Review of the Report "Simulation of Earthquake  
Ground Motions for San Onofre Nuclear Generating  
Station Unit 1, Supplement I"

A Report prepared for the Nuclear Regulatory Commission

J. Enrique Luco

8 October 1979

FIG. 1 SMOOTHED 2% VELOCITY RESPONSE SPECTRA

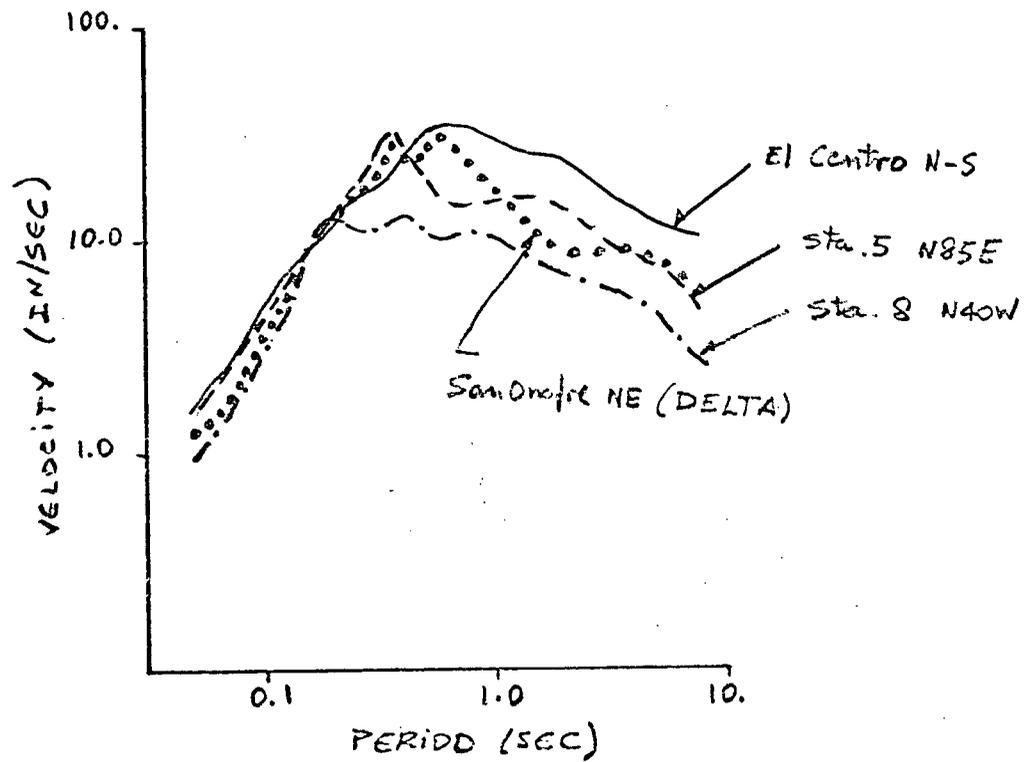
the observed motion by a factor of two. Also, the NE San Onofre spectrum falls below the sta. 5 N85E spectrum for frequencies higher than 5 cps (Figure 1). This effect may be caused in part by the unrealistically low values of Q used which tend to eliminate the high frequency components of motions.

- (iv) The calculated NE San Onofre spectrum falls below the El Centro N-S and station 5 N85 E spectra for frequencies higher than 5 cps. (Figure 1)
- (v) a peak acceleration of 0.8g for an earthquake of magnitude  $M_L = 6.5$  at a distance to the fault of the order of 10 km is consistent with the recommended values in USGS circular 672 and with Trifunac's correlations.

3.2 Recommendation. In my opinion, for an earthquake with local magnitude  $M_L = 6.5$ , Delta's estimates should be multiplied by a factor of the order two. Response spectra consistent with peak accelerations of 0.8g and peak velocities of 60 cm/sec would seem appropriate for the possible conditions at San Onofre for an earthquake of this magnitude. This recommendations is based on the following observations:
